UNITED STATES PATENT AND TRADEMARK OFFICE

| APPLICATION NO. | FILING DATE | FIRST NAMED INVENTOR | ATTORNEY DOCKET NO. | CONFIRMATION NO. |
|-----------------|-------------|----------------------|---------------------|------------------|
| 10/025,821 | 12/26/2001 | Satoshi Shinada | Q67781 | 4266 |

Office Action Summary

DETAILED ACTION

FIG. 1

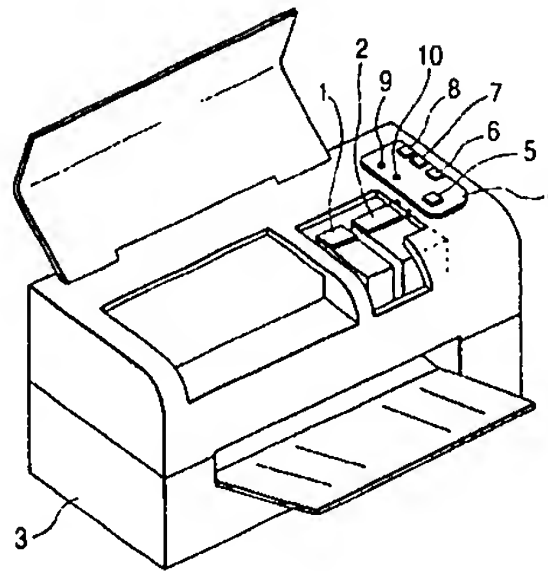
- {claim 1} An ink cartridge for an ink-jet recording apparatus (figure 1, references 1,2);

FIG. 4B

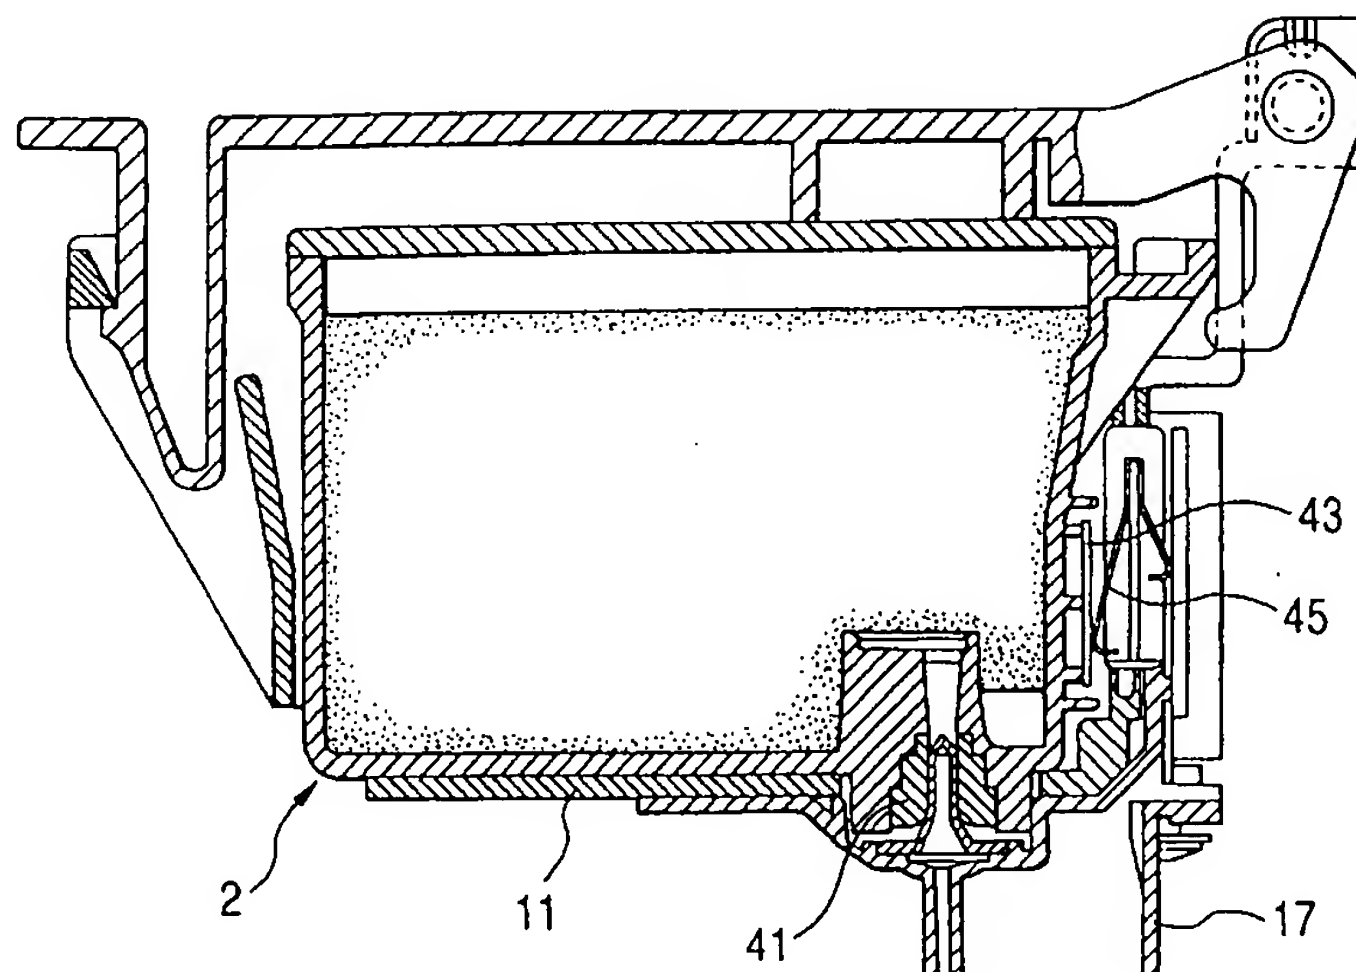
container body having an ink supply port (figure 4B, reference 41; container body drawn in);

- {claim 2} positioning system includes at least one recess that has an opening at a leading end thereof in an ink cartridge insertion direction, and that is engageable with the positioning member formed as a protrusion (figure 4B; positioning recessed portion, guiding protruding portion drawn in; it is seen that when the lever is lifted in a counter-clockwise direction around the gear, positioning recessed portion moves away from the guiding protruding portion; thus in the

- {claim 4} recess has an upper end wall to be contacted with an upper end of the protrusion (figure 4B; upper end wall drawn in)
- {claim 5} the wall extends in parallel to a direction in which the electrodes are arranged (figure 3B; wall drawn in between contact electrodes and positioning recessed portion; it is seen that the wall extends in parallel to a direction in which the electrodes are arranged)

- {claim 10} circuit board having the electrodes is accommodated in a recessed portion formed in the container body (figure 4B, references 43, 45)
- {claim 11} the positioning recessed portion is formed at a position below a circuit board having the electrodes (figure 4B, references 43, positioning recessed portion)

- {claim 20} the positioning system contacts the positioning member to align the electrodes with respective contacts in at least two directions of a carriage moving direction, a paper feeding direction, and a vertical direction in a state in which the electrodes contact the contacts (figure 4B, reference 43, 45)

- {claim 21} the positioning system contacts the positioning member to align the electrodes with respective contacts in at least two directions of a carriage moving direction, a paper feeding direction, and a vertical direction in a state in which the electrodes contact the contacts (figure 4B, reference 43, 45)

FIG. 3B

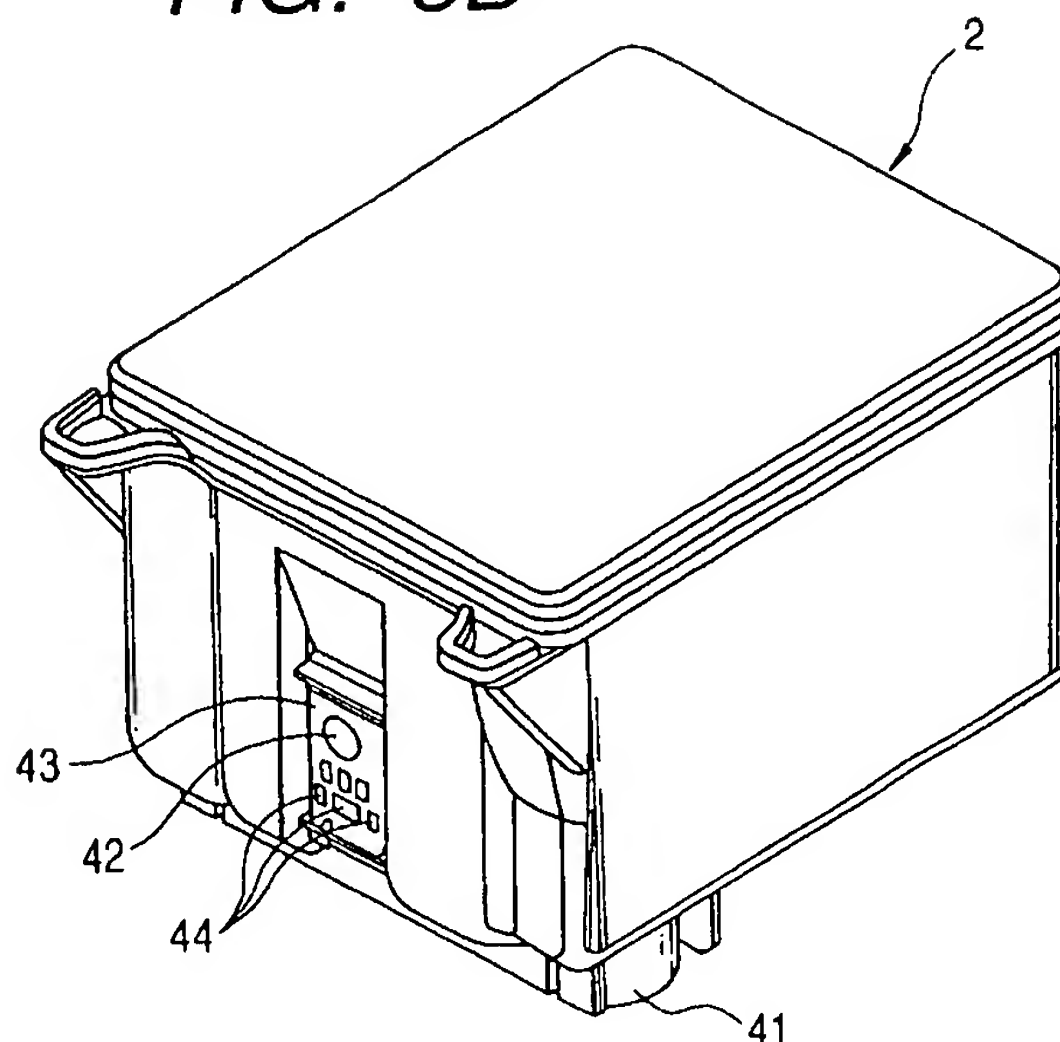
a storage element disposed on the container body (figure 3B, reference 42);

electrodes to be in contact with respective contacts provided in the recording apparatus accommodating the container body therein (figure 3B, reference 44; figure 4B, reference 43 and 45; contacts represent contact electrodes); positioning system which is formed in the vicinity of the electrodes and is adapted to engage a positioning member of the recording apparatus, wherein the positioning system contacts the positioning member (figure 4B; hook portion, lever, protruded portions, gear, and projections drawn in; it is seen that when the lever is lifted in a counter-clockwise direction around the gear, the projection engages the protruded portions, which behave as positioning members for the recording apparatus; thus the claim is naturally suggested in the invention)

- {claim 3} at least one recess includes a pair of recesses located opposite from each other with respect to the electrodes (figure 3B; additional recess drawn in; it is seen that positioning recessed portion and additional recess are located opposite from each other with respect to the electrodes)

- {claim 6} a contact area between the wall and the positioning member is wider than a width of an area in which the electrodes are arranged (figure 3B; the width of the area between the wall and the positioning member is [W1] and the width of the area in which the electrodes are arranged [W2] are drawn in; it is seen that $W1 > W2$)

- {claim 8} the storage element and the electrodes are mounted on a same flexible cable (figure 3B, references 42, 44; column 3, lines 19-21; figure 3B shows the storage system being on the same cable strip as the electrodes and column 3 teaches that the storage element is located on a flexible cable; thus it is inherent to the invention that the electrodes are also located on the flexible cable)

The applicant submits that “the ‘protruded portion’ of figure 3B is not a positioning system which is formed in the vicinity of the electrodes, as recited in claim 1. As shown in figure 3B, the protruded portions are located at the top right and left corners of the front face of the jet ink cartridge, away from and not in the vicinity of the electrodes 44. To the contrary, in Seino, the electrodes 44 are formed in the lower half of the front face of the jet ink cartridge, away from the protruded portions. Furthermore, nowhere in Seino is there any disclosure of a positioning system which contacts the positioning member, as recited in claim 1. Since the Examiner has not shown how the positioning system which is formed in the vicinity of the electrodes and which contacts the positioning member is inherently disclosed to one skilled in the art, Applicants submit that claim 1 is patentable.” The examiner submits that though the figures of Seino et al don’t explicitly show, the protruded portions (as drawn in) engaging the projections (as drawn in) to form a positioning system, the positioning system is there nonetheless. It should be clear to one of ordinary skill in the art that the projection must meet the protruded portions in order for the ink supply needles to engage the ink supply port and for the circuit board to meet the contacts of the recording device. The rotating action is not explicitly shown, but is always the case for a set-up as shown in figure 4B. Hence, the examiner maintains that the claimed limitation is inherent to the invention of Seino et al.
